Re: Timberland Branch Subdivision developed by Joslin Development Group, LLC

I am writing on behalf of Joslin Development Group, LLC (the "Developer") to respectfully request a variance from the Tyler County Subdivision Regulations (the "Regulations") for Timberland Branch located off County Road 4300 and Jose Falcon Survey, Abstract No. 15, Tyler County, Texas (the "Subdivision"). The specific provisions that the Developer is requesting variance on are set forth below.

CONSTRUCTION PLANS FOR PROPOSED TIMBERLAND BRANCH SUBDIVISION TYLER COUNTY, TEXAS AUGUST 2022

PLAT OF
 TIMBERLAND BRANCH
 A SUBDIVISION OF 387.165 ACRES
 CONSISTING OF 20 TRACTS OF LAND
 AS SITUATED IN THE
 JOSE FALCON SURVEY, A-15,
 TYLER COUNTY, TEXAS

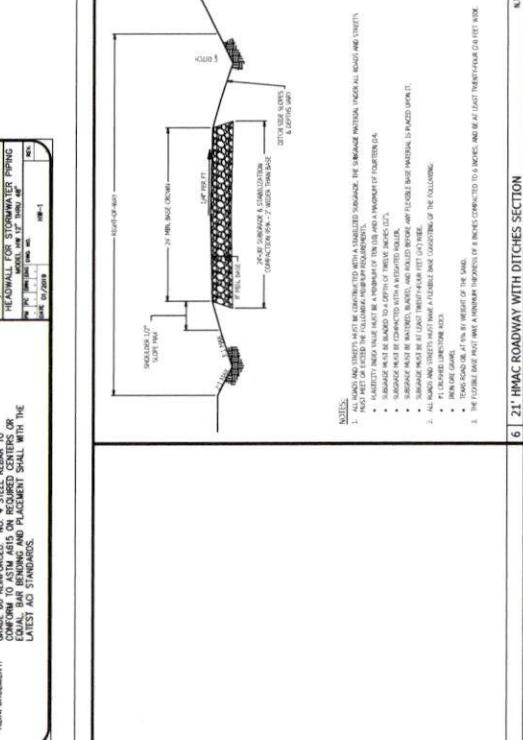
1. Provide the acreage of the road, as well as the length and right-of-way width. (Section 7.1.b.8)
2. Provide the 100-year floodplain on the plat. If not present, in the subdivision, so state, with reference to source. (Section 7.1.b.14).

3. Place the road name/number on the plat. (Section 7.1.b.15).
4. Provide documentation regarding how drinking water will be supplied. (Section 2.2)(Section 6.3.c).

- a. Provide a revised fieldnote description with corrected spelling errors. (Section 7.1.b.5)
- b. Place the Point of Beginning on the plat. (Section 7.1 .b.5)
- c. Provide the total number of lots within the subdivision. (Section 7.1.b.7)
- d. Certificates on plat should reflect the correct month.

Developer has addressed Items 1, 2, 3, a, b, c, and d from the list above with the latest revision of the subdivision plat included with this letter. Regarding items 4, 5, 6, 7, 8, 9, 10, 11, 12, and 13, I address those items below:
